Reedisha Knitex Ltd (Extension)

Dhanua, Nayanpor, Sreepur, Gazipur

5 December 2023

Observation-1: Stress in column exceeds normal design limit. (Old Admin Building)

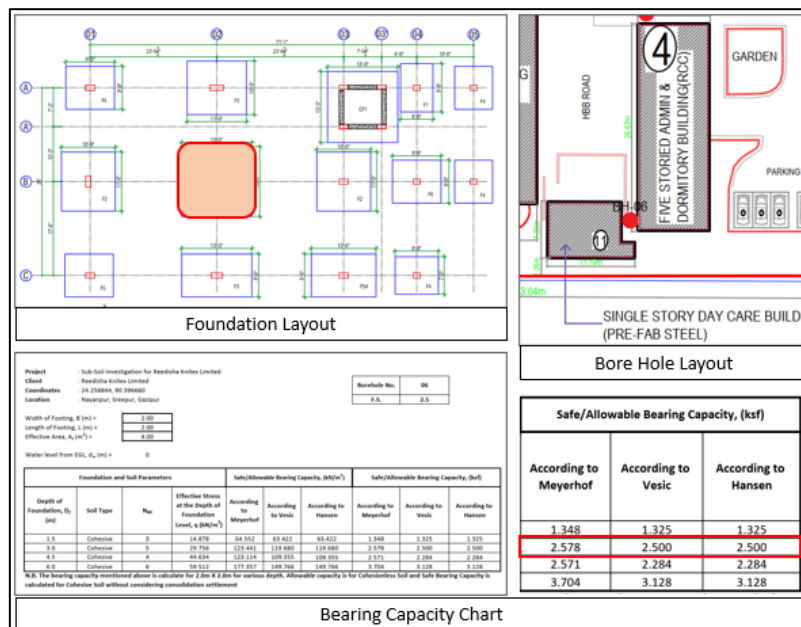
Description: The cursory calculation indicates that column stress exceeds the normal design limit considering a typical floor live load of 3kPa, roof live load of 1.5 kPa, and minimum concrete strength based on aggregate type. The building engineer is required to review the design, loads, and column stresses for the marked columns based on in-situ material strength.

Figure 2.8.5: Applied Live Load on Roof in psf

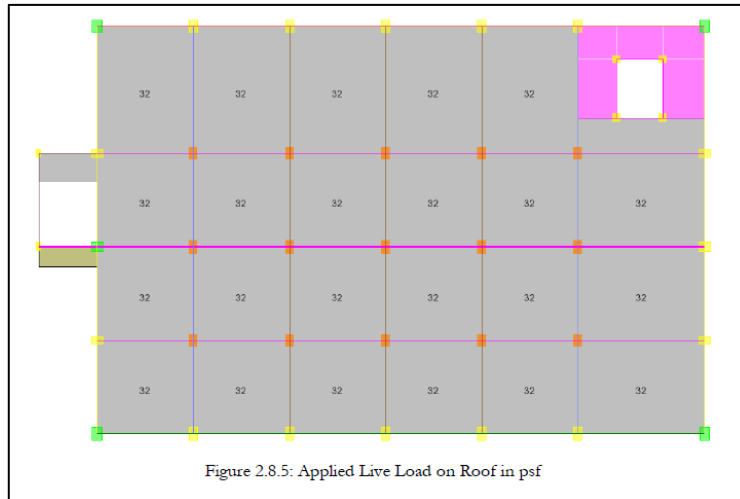
Observation-3: Missing water tank load on FEM model (Printing Building).

Description: Two plastic water tanks (capacity of 2000L) were observed on the stair roof. In FEM model water tank load has not been applied on stair roof. Building engineer is required to apply water tank load on stair roof in the FEM model and incorporate the results in the design report.

Observation-4: Storage rack without anchorage (Printing Building & General Store Shed).

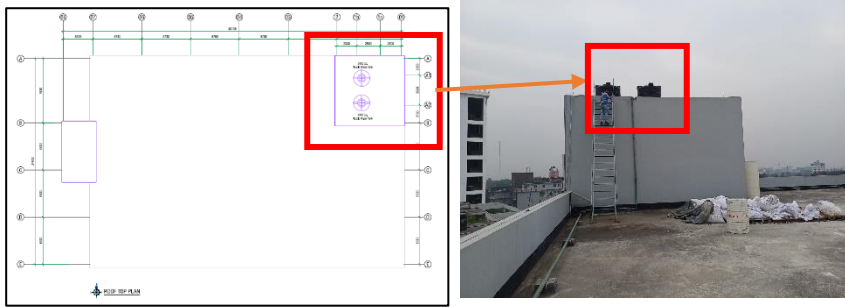
Description: Racks on different floors are not adequately anchored or braced to resist lateral (earthquake) forces. Building engineer is required to adequately anchor and brace all non-structural elements to resist earthquake forces to comply with the BNBC.

Observation-6: Structural connection between two building (Old admin Building & New admin Building).

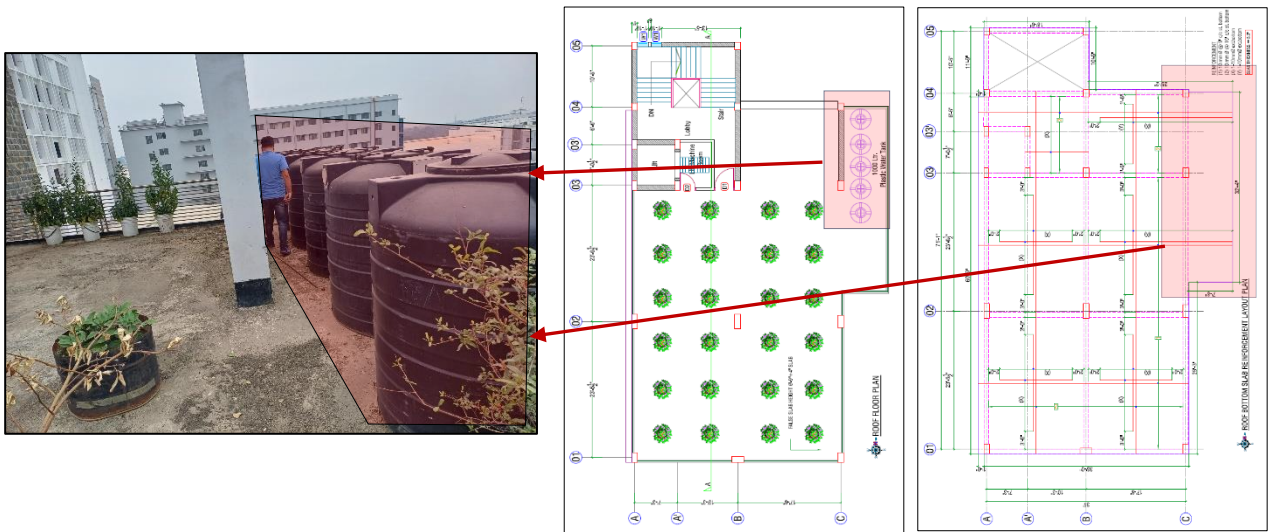
Beam and slab are connected between Old Admin Building and New Admin Building

Description: During inspection it was found that beams and slabs are connected in the new admin building and old admin building. The Building Engineer is required to check the structural integrity of two buildings for the structural connections. Otherwise, separate the connections.

Observation-7: Water tank on cantilever slab (New Admin Building).

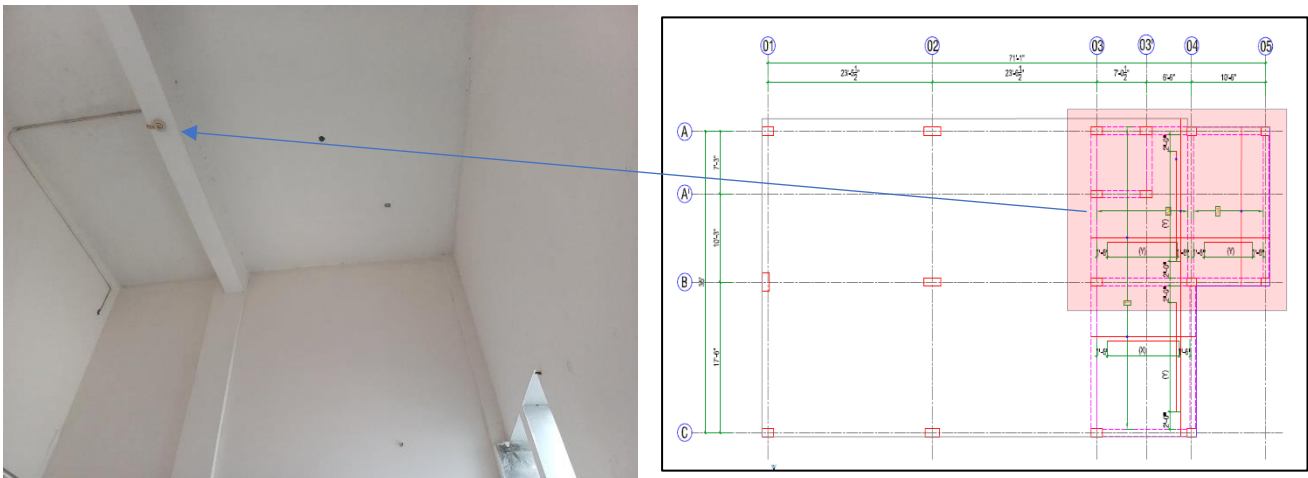
5 Nos 1000L water tank on roof slab at cantilever portion

Description: 5 no's water tank was found on roof slab which was placed on the cantilever portion of the slab. Building Engineer is required to check the slab adequacy of slab for water tank loading.

Observation-8: Discrepancies in as built drawings (New Admin Building).

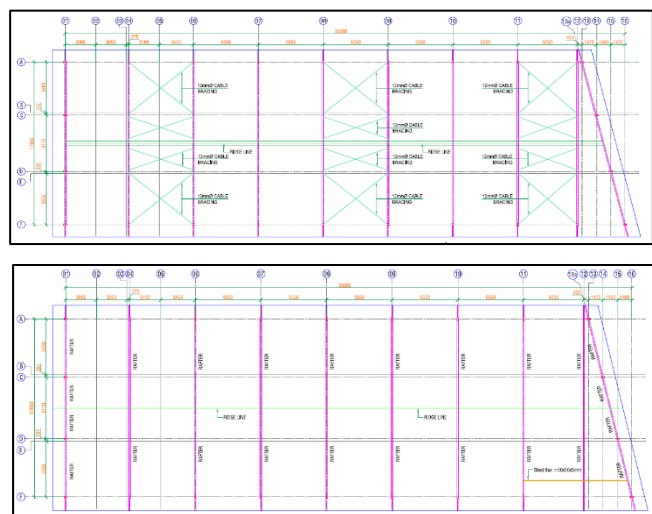
Description: Beams in stair top are missing in as-built drawings. Building engineer is required to update the as built drawings as per site condition.

Observation-11: Lack of lateral stability system and non-engineered connection (Utility Shed-2).

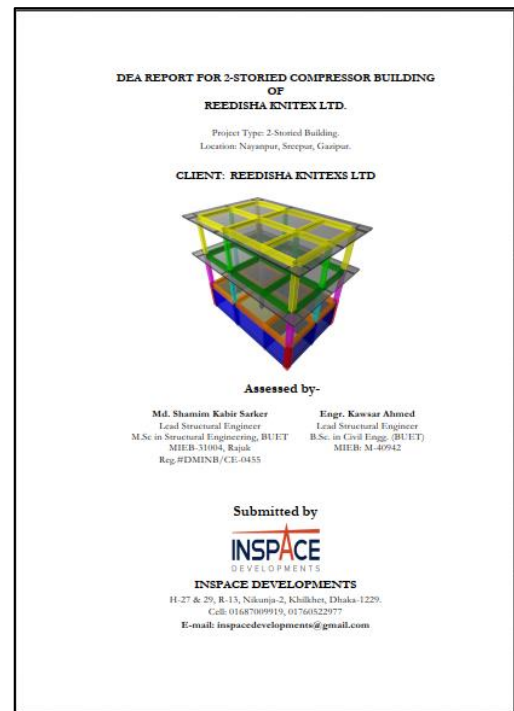
Description: Lack of lateral stability system (strut and bracing), apparent inadequate members and non-engineered connection was observed. The building engineer is required to check the member, connection & stability system of the structure and suggest proper alternatives accordingly.

Observation-13: Lack of information in as-built drawing. (Dyeing Shed-1)

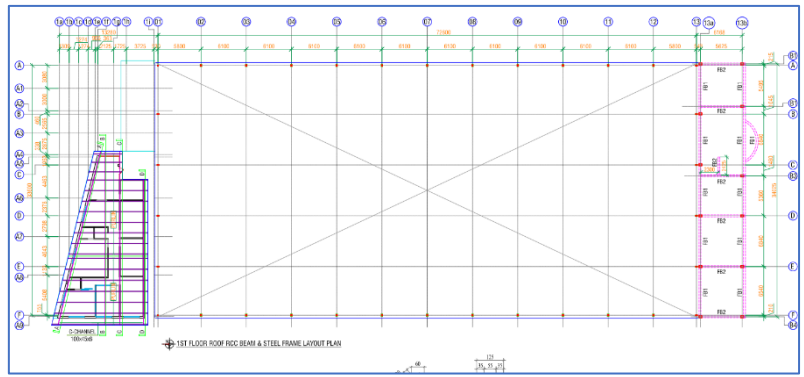
Description: No structural details were found for North side extension of 1st floor. The building engineer is required to survey the structure and prepare accurate as-built drawings.

Observation-15: Lack of lateral stability system. (Dyeing Shed-2)

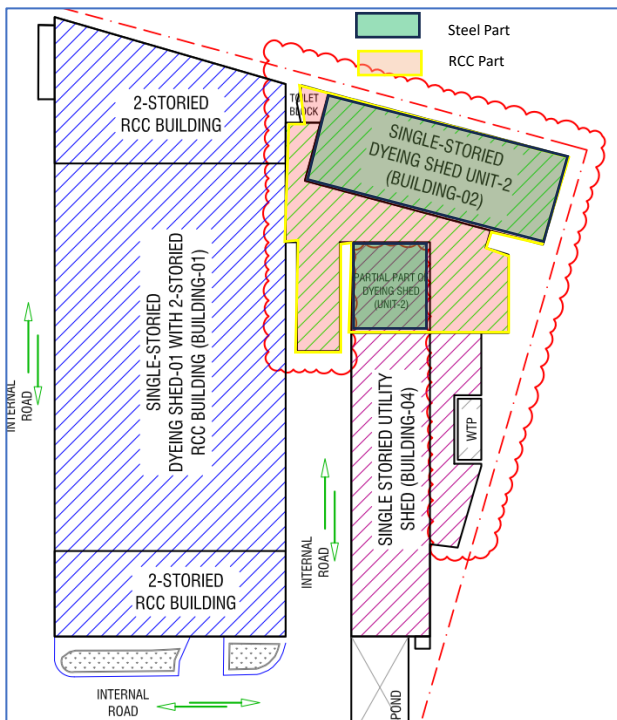
Description: Load transfer media is not provided at ridge along long direction for this shed. Therefore, the lateral stability system of the roof is apparently incomplete. The building engineer is required to check the stability system of the existing structure.

Observation-18: Corrosion in steel member. (Utility Shed)

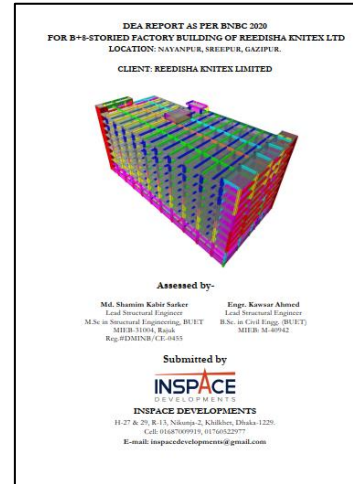
Description: Corrosion in steel member was observed in the several locations. The building engineer is required to remove the corrosion and apply anti-corrosive coating to the steel members.
